- Request - Major Site Plan Review for Multi-Family Housing
- Location - 1401 Monroe Street
- Applicant/Owner - Lucas Metropolitan Housing Authority
424 Jackson Street
Toledo, OH 43604

Staff recommends that the Toledo City Plan Commission approve SPR24-00098, Major Site Plan Review for multi-family housing at 1401 Monroe Street for the following **three (3) reasons**:

The staff further recommends that the Toledo City Plan Commission approve SPR24-00098, Major Site Plan Review for multi-family housing at 1401 Monroe Street, subject to the following **fifty-four (54) conditions**:

MAJOR SITE PLAN REVIEW
TOLEDO CITY PLAN COMMISSION
REF: SPR24-00098
DATE: January 16, 2025
TIME: 2:00 P.M.

SITE PLAN

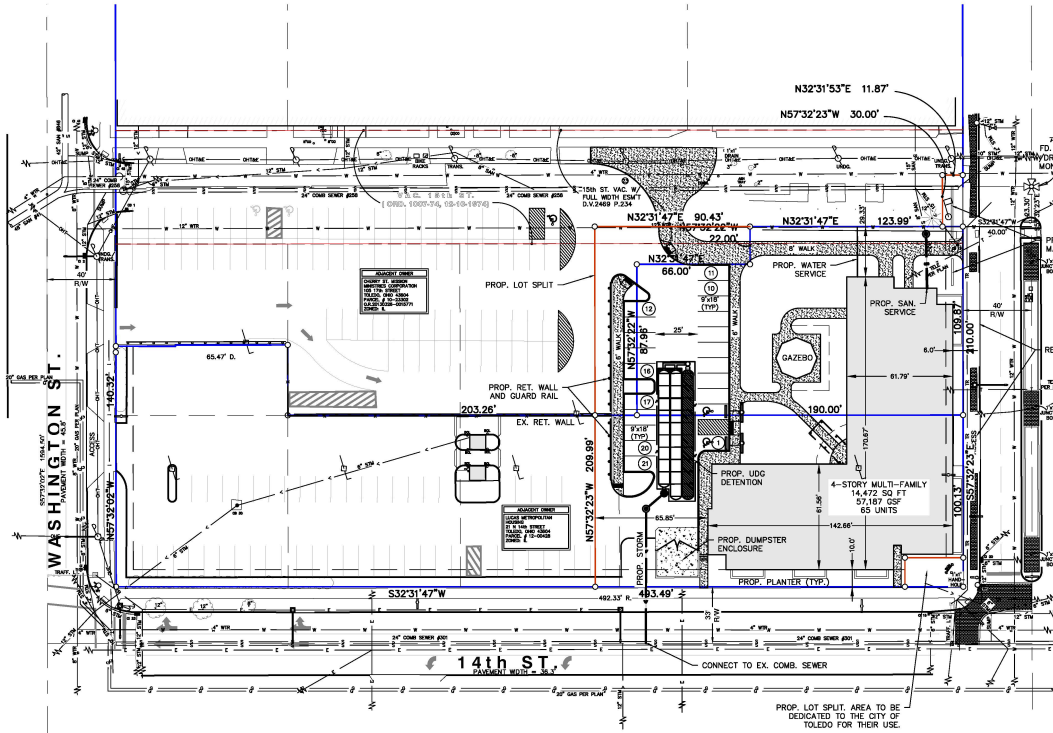
39. Off-street parking shall be provided per TMC§1107.0304 Schedule A for the proposed multi-family building. A total of one hundred five (105) parking spaces are required. The site plan depicts seventy-three (73) parking spaces. **Not acceptable as depicted. An Alternative Access and Parking Plan, in accordance with TMC§1107.1400, shall be submitted to the Planning Director to allow for a reduction of the required minimum off-street parking spaces, including a shared parking agreement.**

40. Bicycle parking slots shall be provided per TMC§1107.0304 Schedule A for the proposed multi-family use. Eight (8) bicycle parking slots are required. The site plan does not depict any bicycle parking slots. **Not acceptable as depicted. Site plan shall be revised to include the required eight (8) bicycle parking slots.**

41. All spaces reserved for the use by persons with physical disabilities shall adhere to the standards outlined in TMC§1107.1700. A minimum of two (2) car accessible spaces and one (1) van accessible space is required for the site. The site plan depicts two (2) van accessible spaces. **Not acceptable as depicted. The site plan shall be revised to include one (1) additional accessible space in the parking area closest to the building.**

46. Per TMC§1109.0103(A), connecting walkways may cross parking aisles or driveways if distinguished from driving surfaces through the use of durable, low maintenance surface materials such as pavers, bricks, scored concrete or scored and painted asphalt to enhance pedestrian safety and comfort. **Not acceptable as depicted. A distinguishable surface shall be installed on the drive surface from the sidewalk along the south side of the new parking area to the sidewalk that connects to Monroe Street.**

50. The proposed dumpster area shall be relocated so that it is not located along 14th Street and depicted on a revised site plan to be submitted to the Plan Commission for review and approval by the Plan Director.

SITE LANDSCAPE PLAN
SCALE: 1" = 20'

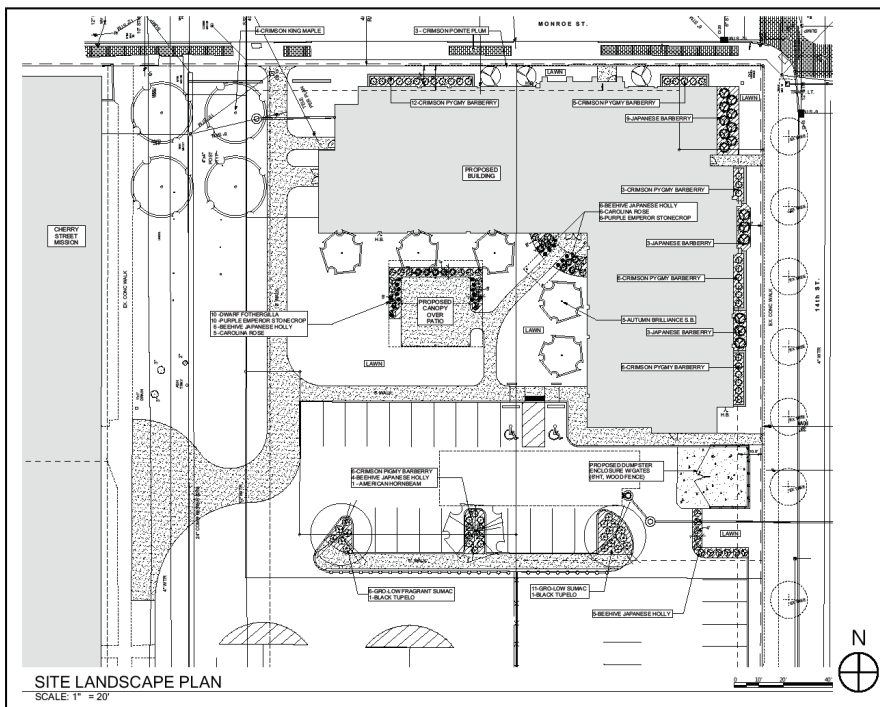
- e. Pursuant to TMC§1108.0305, perimeter landscaping must be installed along any parking lot area adjacent to a street, place, or driveway. **Acceptable as depicted for this phase. When the existing parking area is improved in a future phase, the existing landscape shall be brought into compliance with the applicable landscape requirements.**
